ERRATA for
PE Civil: Structural Practice Exam
ISBN: 978-1-947801-31-8
Copyright 2023
Errata posted 10/01/2024

Revisions are shown in red.

Question 65, p. 48:

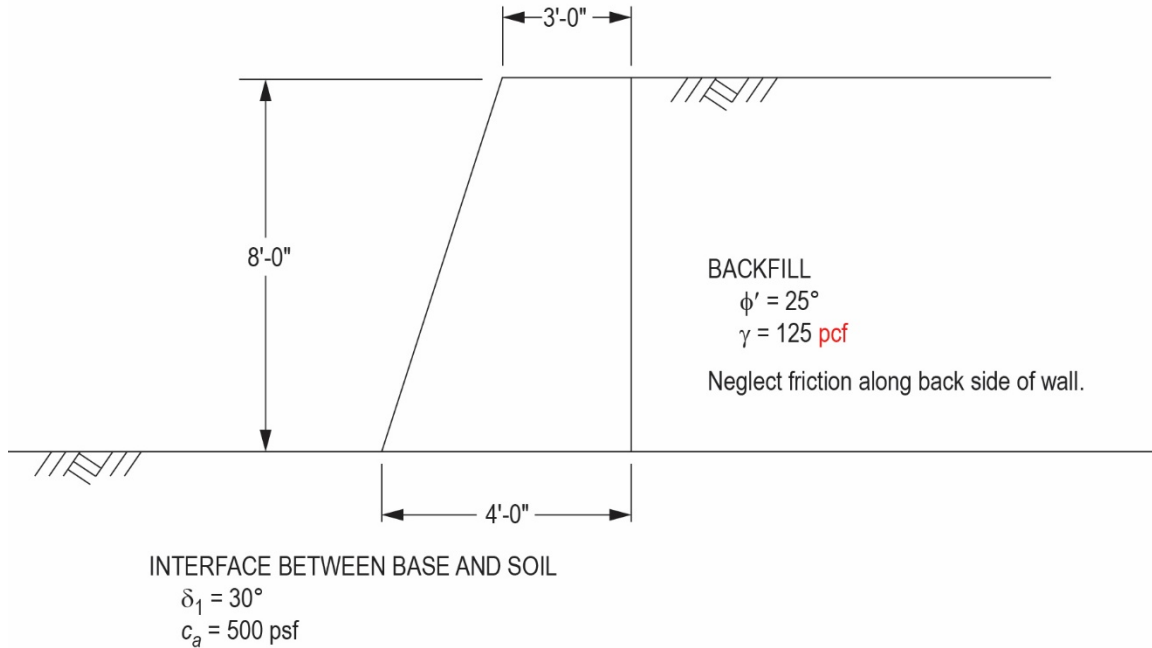
Option B should read as follows:

- B. ASD = **21.3**
LRFD = **32.1**
